**Town of Davidson
Design Review Board Regular Meeting
Town Hall and Community Center
Community Room 120
251 South Street
Wednesday, October 15, 2025 at 5:30 PM**

DESIGN REVIEW BOARD: STAFF REPORT

Date: October 15, 2025
To: Design Review Board
From: Lindsay Laird, Senior Planner
Re: The Pines of Davidson – Formal Review & Recommendation

- **Project:** The Pines of Davidson – New Maintenance Building & Lobby Addition/Renovation
- **Location:** 400 Avinger Lane, Davidson, NC 28036 (Parcel ID 00703127)
- **Applicant:** The Pines of Davidson
- **Designer:** RLPS Architects
- **Planning Area(s):** Conditional

Maintenance Building

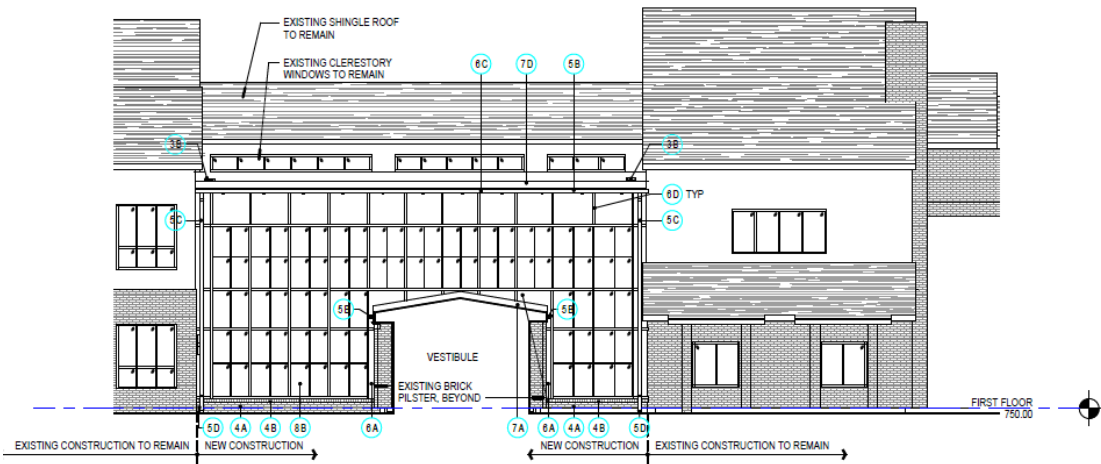
- **Maintenance Building:** The western façade sets the proportions of the rest of the building facades – DRB members felt that windows could be slightly larger.
- **Community Center Addition:** Add verticality to glass.
